Access Compliance Report

Public Rights-of-Way

Intersection ID: 9243	Main Street: DEAN_ST	Cross Street: WADDELL_ST	Location:	N
ADA ID: ECA06427A2A6	Ramp Type: BlendTrans2	Initial Pass/Fail: Pass	Overall Compliance: No	Severity Score: 0.25
Codes/Mitigation Info/Possible Solution		Field Measurements/Component Compliance

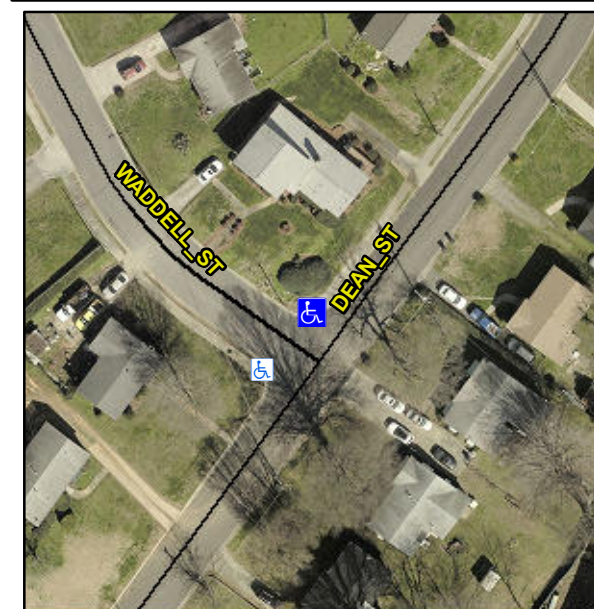
R304.5.3, R304.2.3, R305.2

Compliance	Description	Data	Compliance	Description	Data
N/A	Ramp Length (in)	71.0	Yes	BlendTrans Slope (%)	2.2
Yes	Ramp Width (in)	60.5	No	BlendTrans XSlope (%)	2.8
Yes	Flare Type LCurbed_NoWalkSurface	N/A	N/A	Flare Type RT	Sloped
N/A	Flare Slope LT (%)	N/A	No	Flare Slope RT (%)	N/A
N/A	Flare Traversable LT?	No	N/A	Flare Traversable RT?	Yes
N/A	Landing Length (in)	N/A	Yes	DWS Provided?	Yes
N/A	Landing Width (in)	N/A	Yes	DWS Contrast?	Yes
N/A	Landing Slope (%)	N/A	Yes	DWS Length (in)	24.0
N/A	Landing X Slope (%)	N/A	Yes	DWS Full Width?	Yes
N/A	Landing Curb? (Y/N)	Yes	No	DWS Offset (in)	3.0
N/A	Shared Landing?	No			
Yes	Gutter Ponding?	No	Yes	Gutter Slope (%)	3.5
Yes	Gutter Lip Ht (in)	0.0	No	Gutter X Slope (%)	4.7
N/A	Painted X Walk1?	No	N/A	Painted X Walk2?	N/A
	X Walk 1 Direction	To SW		X Walk 2 Direction	N/A
	X Walk 1 Width (in)	N/A		X Walk 2 Width (in)	N/A
	X Walk 1 Slope (%)	6.3		X Walk 2 Slope (%)	N/A

X Walk 1 X Slope (%)	2.3		X Walk 2 X Slope (%)	N/A
N/A	Ramp inside XWalk1?	N/A	N/A	Ramp inside XWalk2?	N/A
	Road Slope (%)	2.3		Clear Space?	Yes
	Road X Slope (%)	6.3	N/A	Clear Space to XWalk (in)	N/A
Yes	Any Obstructions?	No	Yes	Storm Grate/Utility Hazard?	No
	Obstruction Type			Storm Grate/Utility Type	
			N/A		N/A
			Yes	Surface Condition? (G/P)	Good
			N/A	Curb Slope (%)	3.0

Remove & Replace Curb Ramp With Two New Directional Ramps or Equivalent. Remove & Replace Gutter.
